**SUBJECT: REVISION "A" TO TECHNICAL BULLETIN 206-99-196:  
TRANSMISSION INPUT ADAPTER MODIFICATION AND  
PACKING A10710.V720, INTRODUCTION OF.**

No. 206L-99-196

**SUBJECT:** TRANSMISSION INPUT ADAPTER MODIFICATION AND PACKING A10710.V720, INTRODUCTION OF.

**Figure 1. Input Adapter Modification**

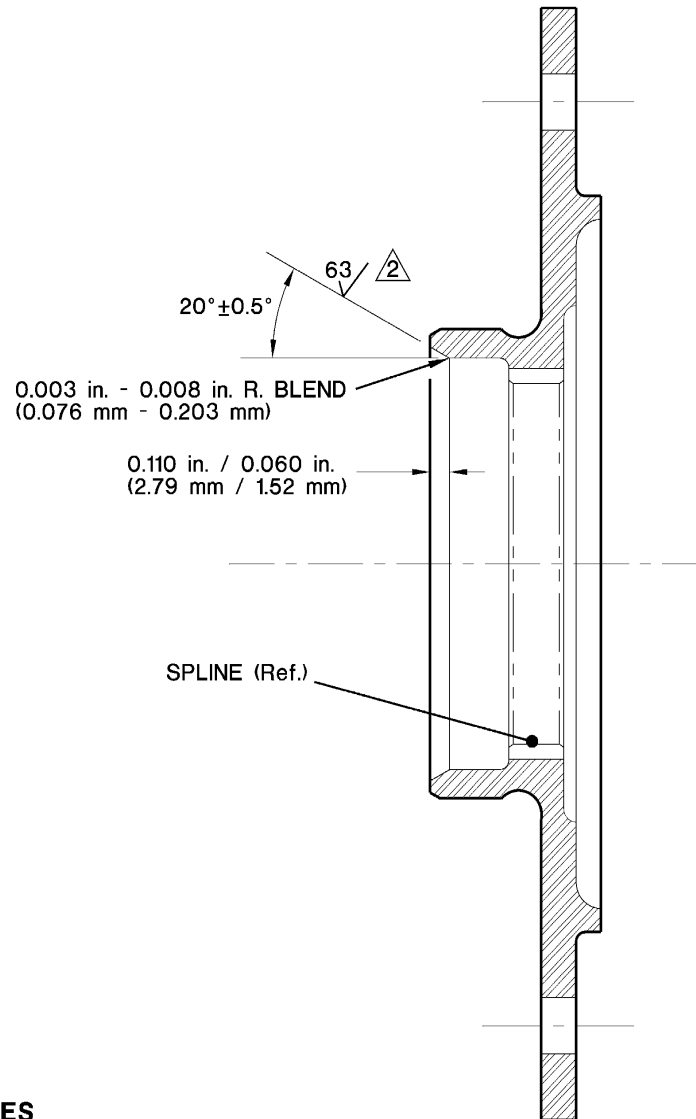
This bulletin also gives instructions for the addition of a chamfer to input adapters, 206-040-048 and 406-040-070.

The addition of a chamfer to the adapter 206-040-048 and 406-040-070 will make it easier for the adapter to slide over the packing A10710.V720. However, it is still possible to install the new packing without this modification being accomplished on the adapter.

6. To minimize the effort required during assembly, modify the input adapter as shown of Figure 1.
7. Lubricate packing A10710.V720 with Fluid #1 (C-024).
8. Install packing A10710.V720 as a replacement for A9854.16347, A09854.V720, L1523 series and L-1523 series.
9. Install the input adapter, magnetic carbon seal and housing (BHT-206L-SERIES-CR&O).
10. Fill the transmission with oil (Maintenance Manual Chapter 12).
11. Install the main driveshaft (Maintenance Manual, Chapter 63).
12. Install the cowling you removed in Step 2 (Maintenance Manual, Chapter 53).

1. Break all sharp edges.
2. Surface finish to be 63  $\mu$ in. (1.6  $\mu$ m) RMS.
3. Applicable to couplings:  
206-040-048-001  
206-040-048-003  
206-040-048-101  
406-040-070-101  
406-040-070-103
4. Positional run-out 0.010 in. (0.254 mm) max.
